Hydrol. Earth Syst. Sci. Discuss., 9, C6512-C6525, 2013

## Interactive comment on "Experiences in using the TRMM data to complement rain gauge data in the Ecuadorian coastal foothills" by M. Arias-Hidalgo et al.

Interactive comment on "Experiences in using the TRMM data to complement rain gauge data in the Ecuadorian coastal foothills" by M. Arias-Hidalgo et al.

Fig. 1.

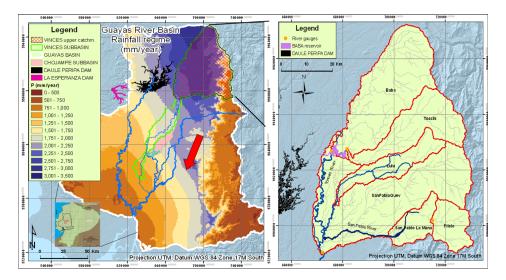
Figure 1, The Vinces sub-basin boundary is not clear. The locations of river gauges for each catchment are needed.

- pg. 12438, line 27-28 Please specify what you mean when you indicate that simulations were not accurate. RESPONSE TO THE REVIEWER: The line has been rewritten: Although the outcomes of those simulations showed some biases when compared with an existent hydrological model, ......" (page 4, line 21 on the revised manuscript)
- 2.1 The Vinces River catchment There are some areas in this section that are very confusing and I agree with reviewer #1 that the location and description of the Vince Sub-basin or the location of streamflow gauges is not clear either in the narrative or in Figure 1. Is there a streamflow gauge at the outlet of each subbasin? The location of the Quevedo at Quevedo station at the basin outlet needs to be emphasized in the narrative? Specific comments include: pg. 12439, line 24-25 The sentence that begins "the drainage area...." is very confusing.

RESPONSE TO THE REVIEWER: Both observations have been incorporated, see the newer versions of figure 1 a and b.

RESPONSE TO THE REVIEWER: Figure 1 has been improved and clarified according to the requests of the two reviewers. Page 5, line 12: "The Vinces River is the third most important waterway in the region, after the Daule and Babahoyo which form the Guayas at Guayaquil City (up to Quevedo station –fig1, 3420 km2, total 5300 km2)." Page 5, line 29: "To that end, the aforementioned catchment was divided into 6 subbasins (Fig. 1b), where four had streamflow gauges available for calibration."
